Technical Bulletin

Front Door Panel, Vinyl Peeling Away Near Door Glass

70 06 09 Nov. 17, 2006, 2005495, Supersedes Technical Bulletin Group 70 number 03-03 dated Sep. 10, 2003 due to inclusion into ElsaWeb.

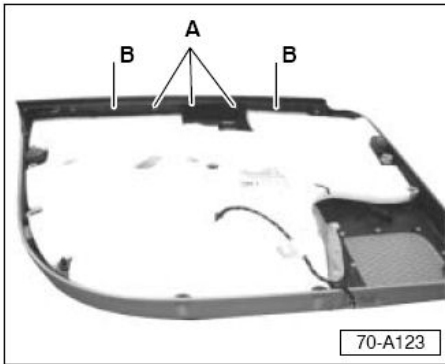
- Lower window completely.
- Raise window to approx. 1/3 closed position.
- Slide Special Tool No: JC4360 (0.3 mm feeler gauge) between glass and door panel from front to rear of panel.

If gauge slides with no resistance:

- No additional work is necessary.

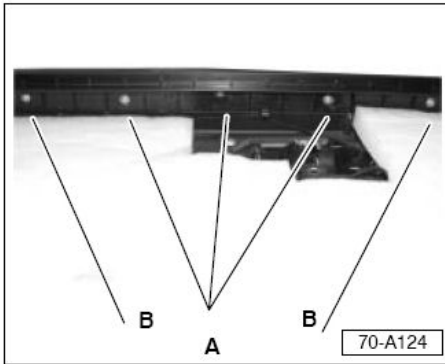
- Locate screws attaching plastic locator channel to door panel -A- and -B-.

- Remove three center screws -A- from plastic locator channel, located on back side of door panel.
- Loosen screws -B- at each side of center screws -A-.

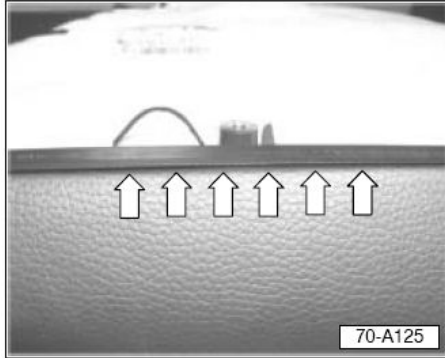
- Insert Special Tool No: JC4350 (0.5 mm feeler gauge) between panel and plastic locator channel at area previously marked with tape (near arrows).

This creates a minimum of 0.5 mm gap between plastic locator and the door panel vinyl.

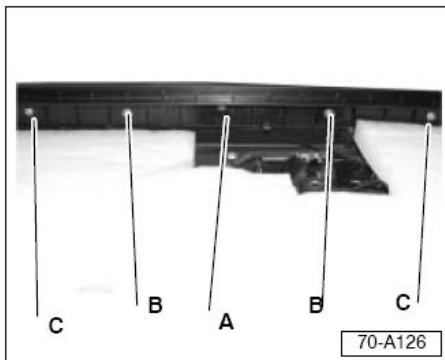
With Special tool No: JC4350 (0.5 mm feeler gauge) held in place:

- Install center screw -A- in a new location on plastic channel.
- Install two remaining screws -B- in new locations on plastic channel.
- Tighten two screws -C- in original holes.

- Remove feeler gauge from door panel.
- Install door panel (see Repair Manual Repair Group 70 – Interior trim, Door trims).
- Using special tool JC4360, verify a minimum gap of 0.3 mm between door panel (vinyl) and glass at areas previously marked with tape.
- Cycle window up and down to verify that no contact between glass and door panel exists.
- Remove marking tape.
